CERTIFICATE OF APPROPRIATENESS

Property: 1507 Ashland Street, lots 15 & 16, block 146, Houston Heights Subdivision. The property includes a historic 1,380 square foot, one-story wood frame single-family residence situated on an 8,800 square foot (66' x 132') interior lot.

Proposal: Alteration – Construct a 480 square foot one-story addition at the rear of the contributing residence and install two shed dormers on the south side of the roof and three shed dormers on the north side.

HAHC Action: Approved

ROOF PLAN

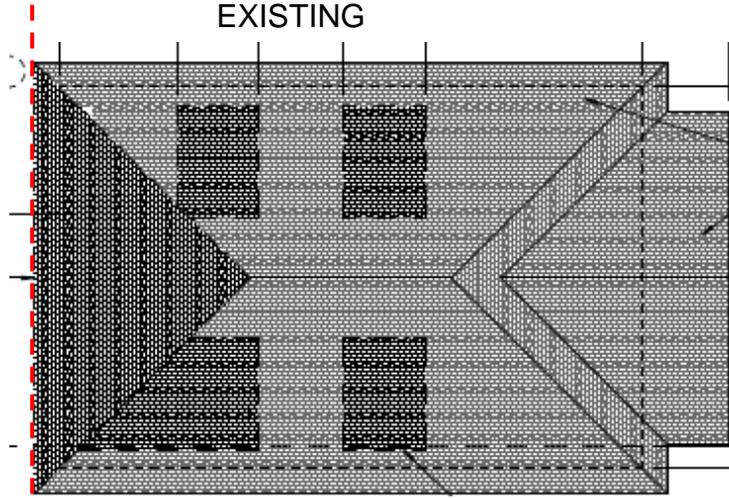
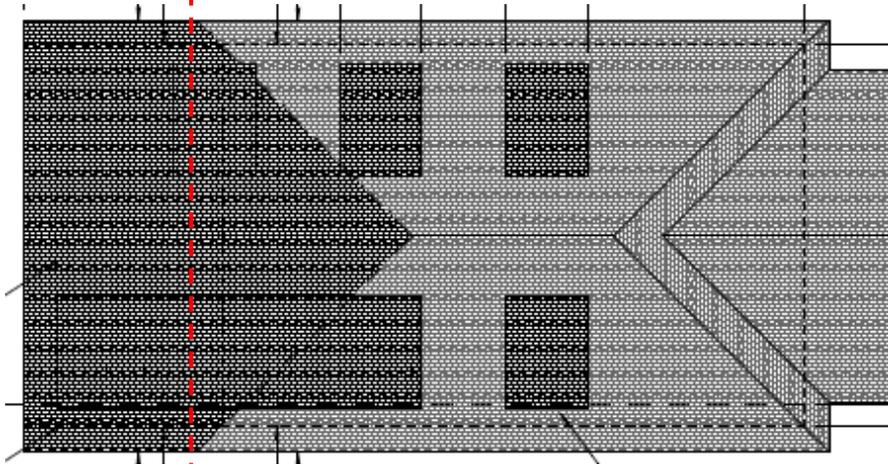
The dormers and flat shed roof addition on top of the existing historic structure is not acceptable nor required. There is plenty of space on site to allow the new structure to be separate from the existing historic structure.
